Subject: 2006 6.0L Diesel Power Stroke Cylinder Head Commonization

Effective Date: Ford Production Assembly Plants - January 11, 2006
Kentucky Truck Plant (Super Duty) & Lorraine Assembly Plant (Econoline)

Figure 1 - New cylinder head

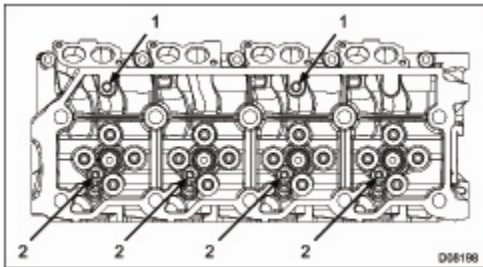
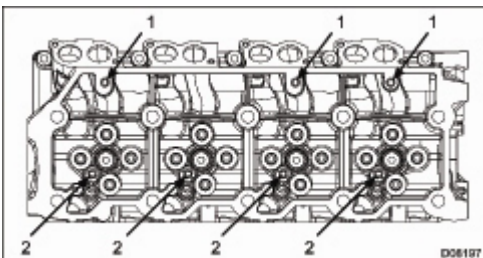
The new cylinder heads have several casting changes including a slight injector clamp bolt hole relocation (2, figure 1) and the carrier boss bolt hole size and location changes (1, figure 1). New cylinder heads also use 32 mm cup plugs replacing the old 28 mm cup plugs.

The cylinder head gasket is also new to accommodate the new 20mm cylinder head location dowels. Pre commonization head use 18mm dowels

Note: At this time the new cylinder head assembly is not interchangeable with the previously level head.

Note: The previous level cylinder head assembly is not interchangeable with the new head.

Figure 3 - New Block Assembly

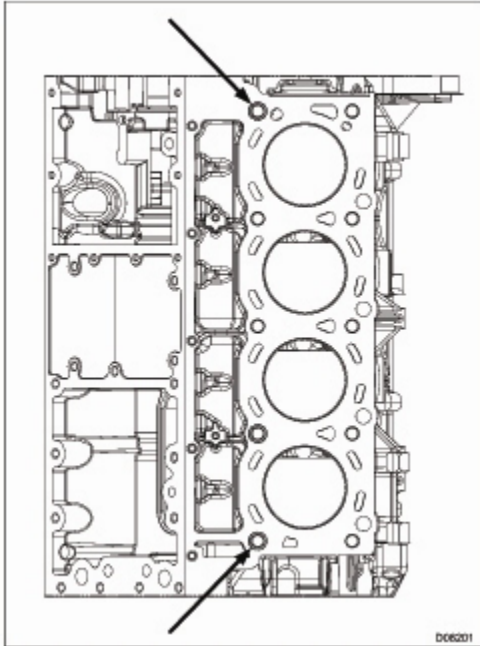
The new crankcase (block) uses two 20mm cylinder head locating dowels per head.

The old crankcase (block) uses two 18mm cylinder head locating dowels per head.

Note: The new and old block assembly is not interchangeable. This affects replacement of all 6009 short blocks and the 6010 bare blocks.

Figure 4 - New Rocker Arm Carrier

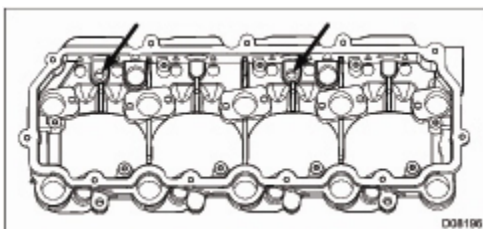
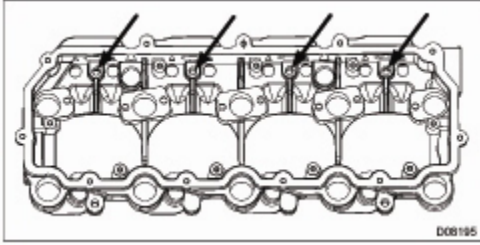
Casting changes to the rocker carrier provide increased clearance for new injector hold down clamps (figure 6). The new carrier also uses only 2 bolts and locating dowels to attach the carrier to the head.

The new rocker carrier is serviced in a Rocker Arm Carrier Kit which includes the rocker carrier cover, gasket and necessary dowels.

Note: The new and old rocker arm carrier kits are not interchangeable.

The old rocker arm carrier uses 4 attaching bolts to hold the carrier to the old cylinder head (figure 2).

Note: The previous level rocker arm kit is not interchangeable with the new kit and will remain available for service.

Figure 6 - New Injector Hold Down Clamp Assembly

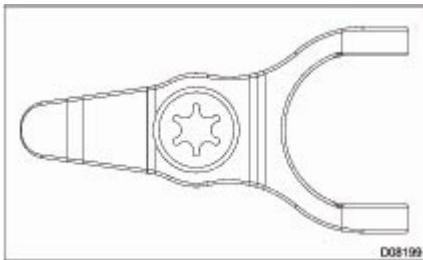
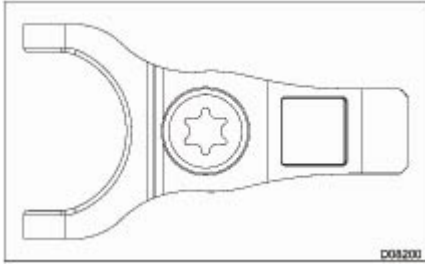
The tail end of the new injector hold down clamp is being reduced to avoid interference with the rocker arm carrier wall. Injector hold down clamp bolt torque will increase from 24 lbf-ft to 25.8 lbf-ft and bolt head size will increase from T40 to T45.

Note: The new and old injector hold down clamps are not in interchangeable.

Note: The new and old injector hold down clamps are not interchangeable. The old injector hold down clamp will remain available for service.
